REMARKS

This application is a continuation associated with prior application Serial No. 08/637,894 filed April 25, 1996. The application was abandoned and a Petition to Revive was filed on May 1, 1999. This Petition was apparently granted since a filing receipt and two Office Actions were issued for this case, however no paperwork showing the grant of the petition has been received by the applicant. The applicant respectfully requests a copy of the paperwork showing that the Petition to Revive was granted.

Proposed Drawing Changes

FIG. 1

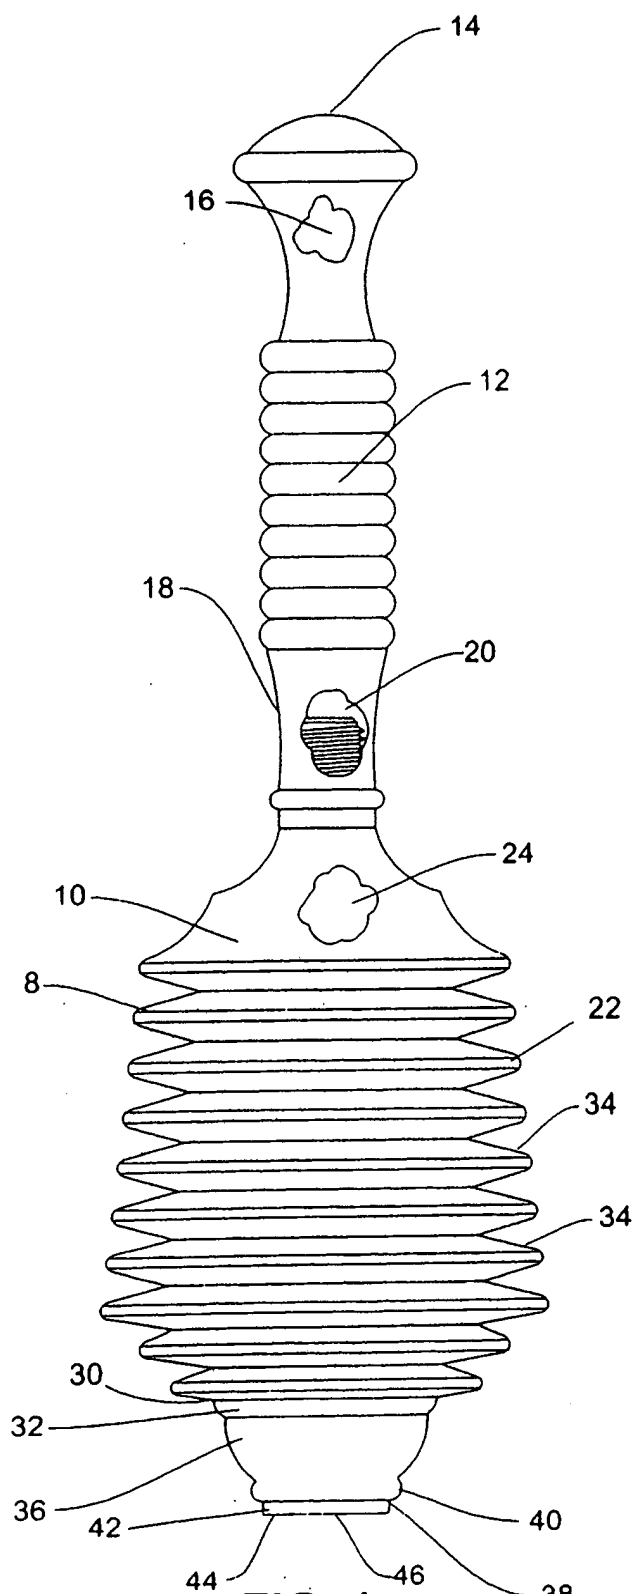
As for support for Claim 16, see FIG. 1, and page 6, lines 17-19, which state,

FIG. 2

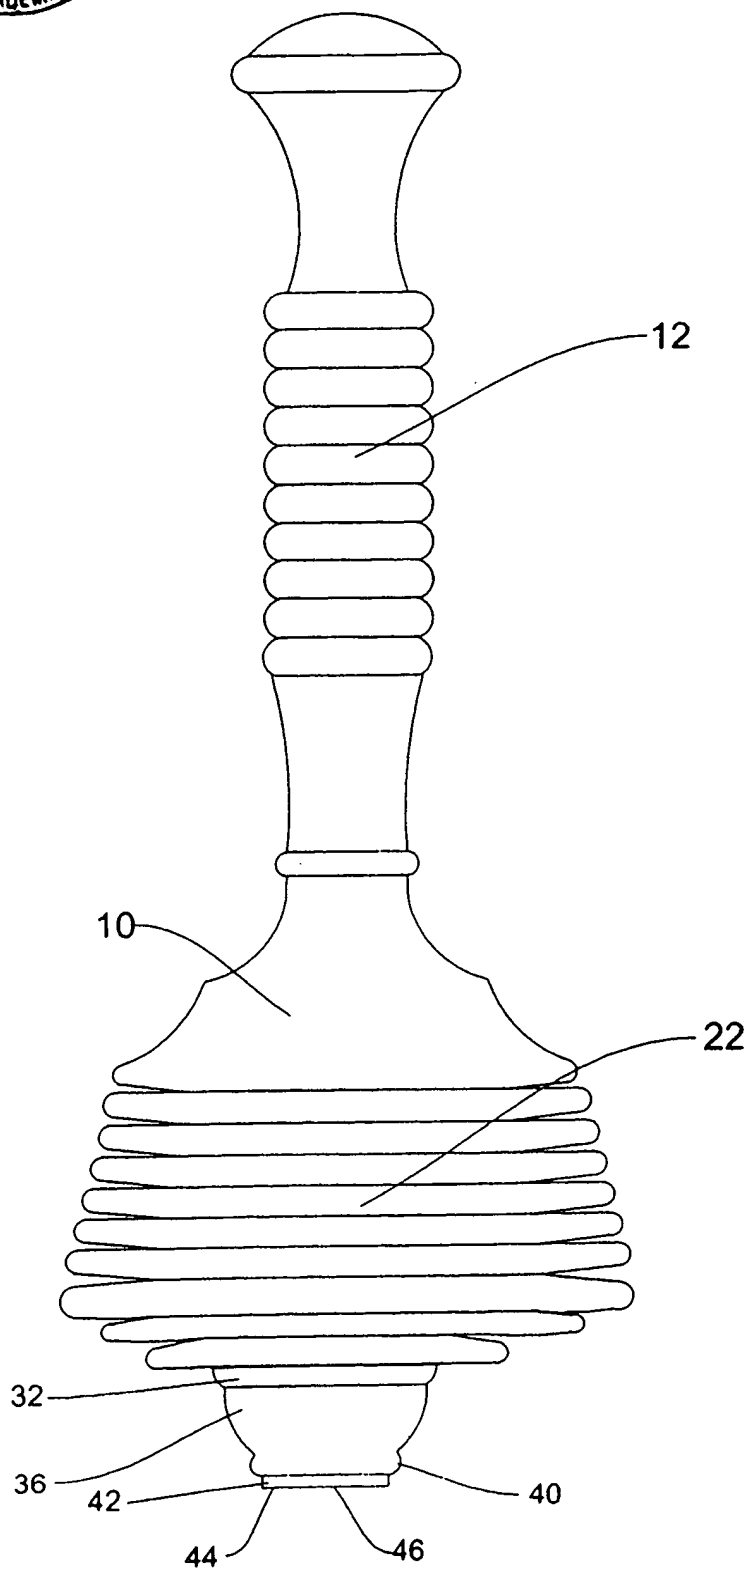
In the previous non-final Office Action the drawings were objected to because the cross-hatching is inaccurate as to the material in FIG. 2 and reference numeral 54 is missing from FIG. 5. Additionally the drawings were objected to under 37 CFR 1.83(a). It was stated that the drawings must show every feature of the invention specified in the claims. The Examiner stated that the integral handle set forth in Claim 17 must be shown or the feature(s) entered from the claim(s).

In response to the previous non-final Office Action, the figures were amended and a proposed drawing change was submitted. Specifically, the applicant was not sure which cross-hatching the Examiner referred to with respect to FIG. 2, as there is no cross-hatching in FIG. 2. The applicant, however, amended some cross-hatching in FIG. 3. The applicant further amended FIG. 5 to show reference numeral 54. Additionally, the applicant added a new FIG. 4 (previously submitted as new FIG. 6), showing a plunger with an integrally formed handle. Support for this change is found in the specification on page 3, lines 20-24, which state,

FIG. 6

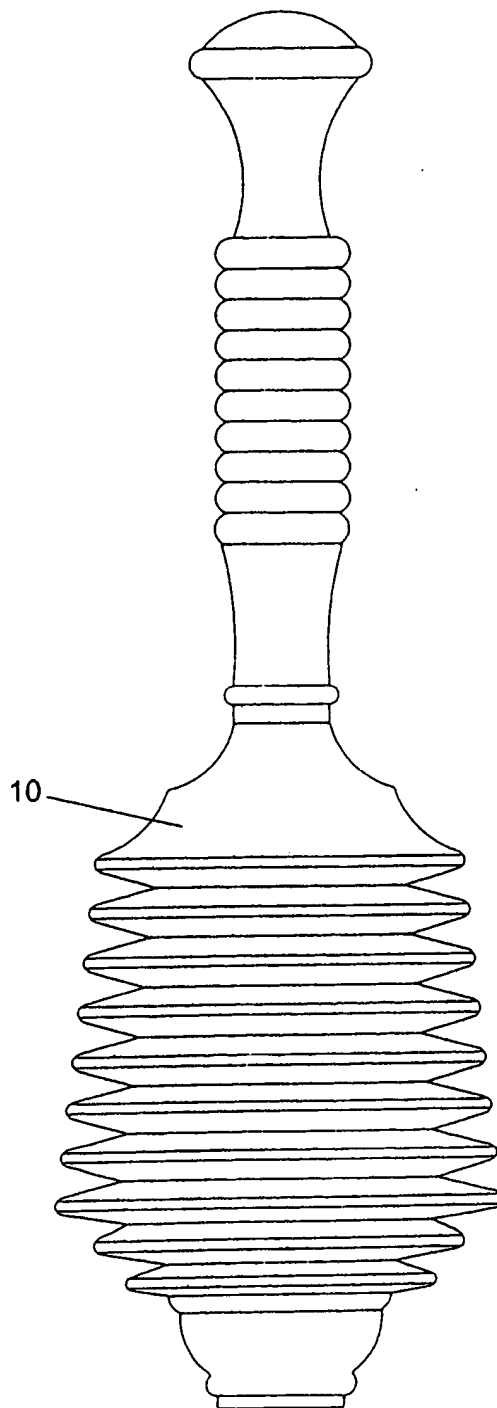
[Figure 4 is a schematic top plan view of a plurality of toilets, a, b, c, d and e, illustrating different toilet bowl openings into which the improved drain plunger of the present invention can fit;]" to,

[Figure 6 is a schematic side view elevation, of a preferred embodiment of the toilet and sink drain plunger of the present invention showing the plunger with an integrally formed handle.]

[Alternately the entire plunger 10 can be of unitary construction, as shown in FIG. 6.] to

Figure 4 is a schematic side view elevation, of a preferred embodiment of the toilet and sink drain plunger of the present invention showing the plunger with an integrally formed handle.

Alternately the entire plunger 10 can be of unitary construction, as shown in FIG. 4.
